SUBJECT: Forwards responses to draft SER Open Items 355-383, discussed  
 at 830921 meeting w/Auxiliary Sys Branch in Bethesda, MD.

SHEARON HARRIS NUCLEAR POWER PLANT  
UNIT NOS. 1 AND 2  
DOCKET NOS. 50-400 AND 50-401  
RESPONSES TO REQUESTS FOR ADDITIONAL INFORMATION

Shearon Harris Nuclear Power Plant  
Draft SER Open Item 355  
ASB Question 3.5.1.1

CURVE N-1212, REV. 0

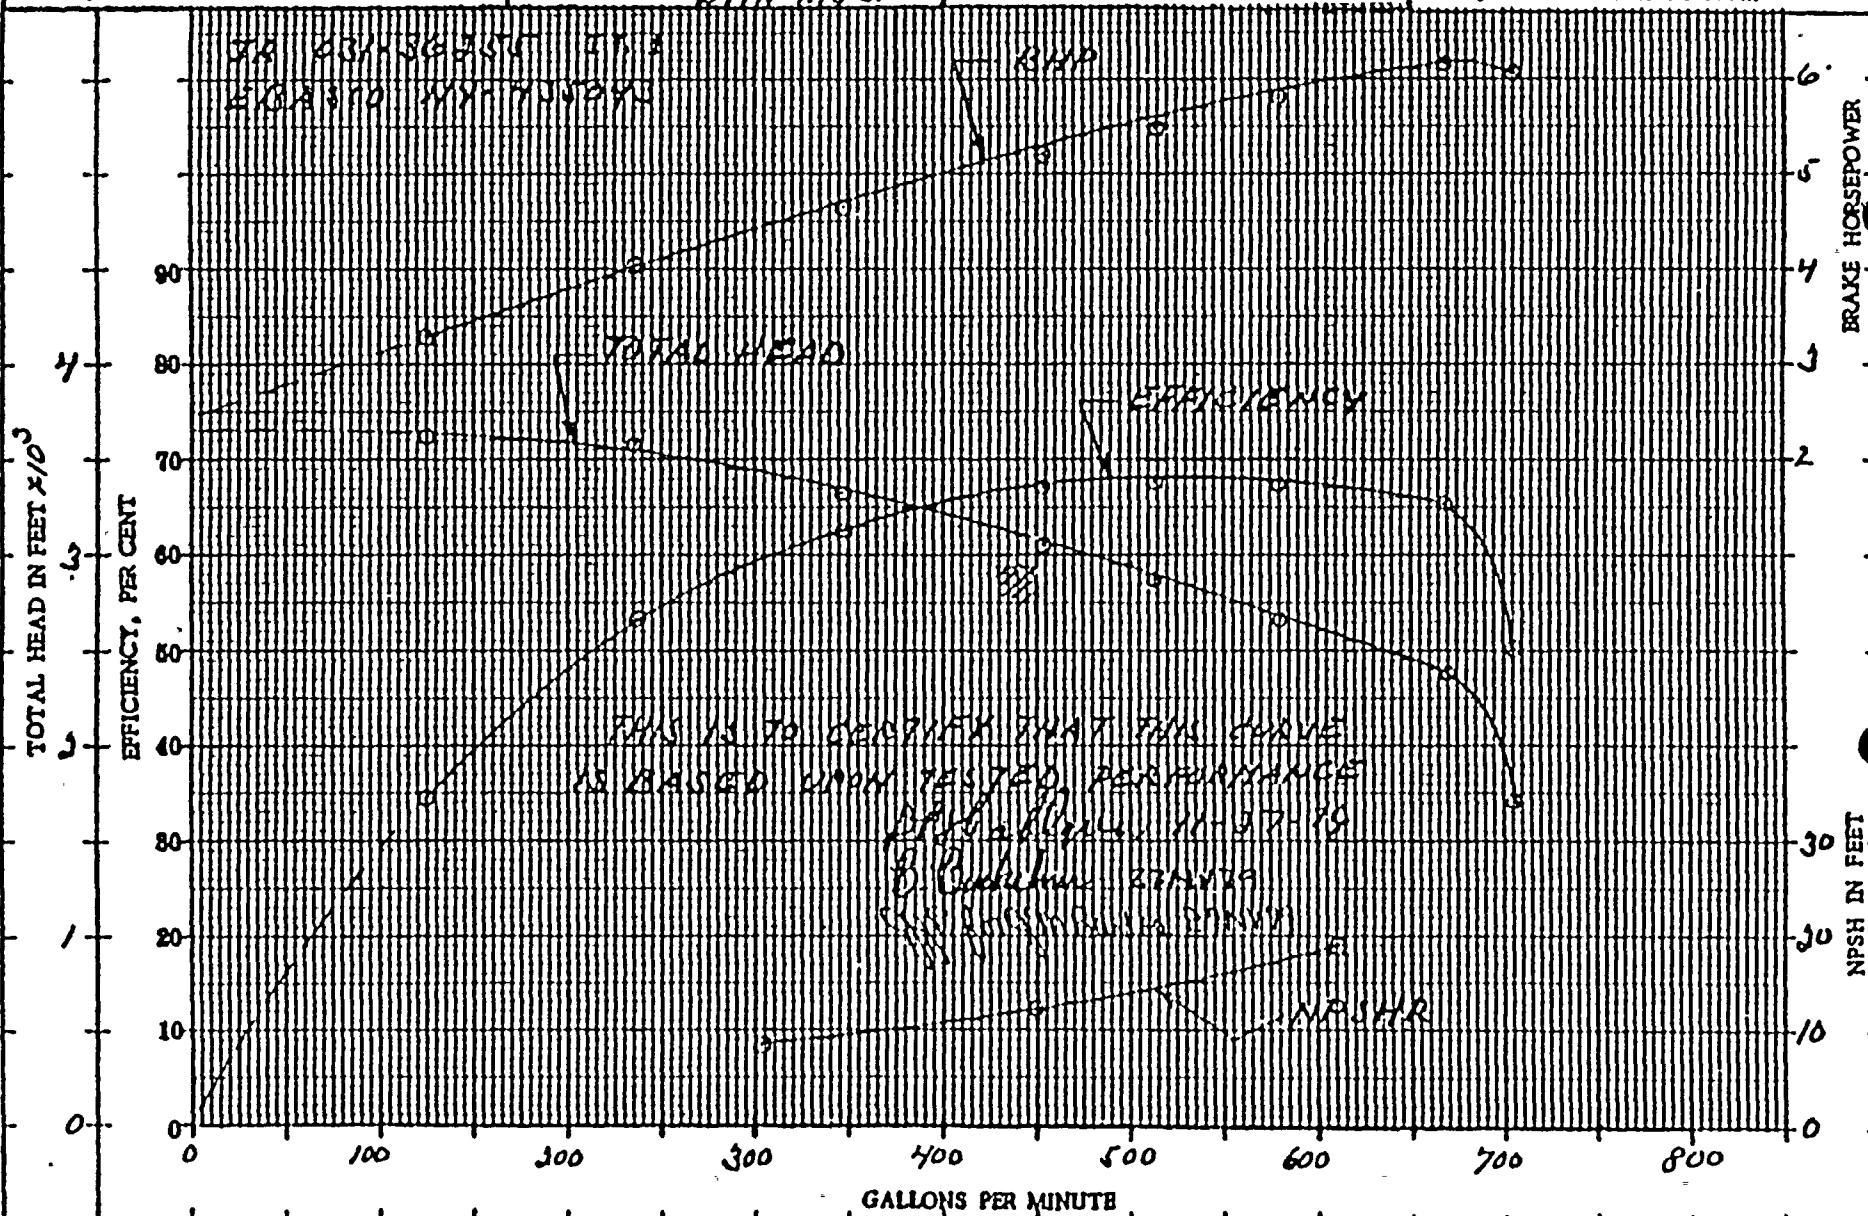
- (1) Provide assurance that at least 475 gpm will be provided to the steam generators by the AFW system after a loss-of-feedwater (LOFW) event.
- (2) Clarify the discrepancy between Table 10.4.9-1 of the FSAR which shows the capacity of the AFW pumps to be 450 gpm while the narrative states the pump capacities to be 475 gpm.

As shown on the attached AFW motor driven pump curve No. 1212, Rev. 0 the pump design condition is 450 gpm but the capacity to deliver 475 gpm is well within the pump capacity.

FSAR Table 10.4.9-1 lists the correct AFW motor driven pump design capacity at 450 gpm. However, as shown on the attached pump curve the pump can deliver the 475 gpm against the pressure relief valve setpoint pressure in the steam generator(s).
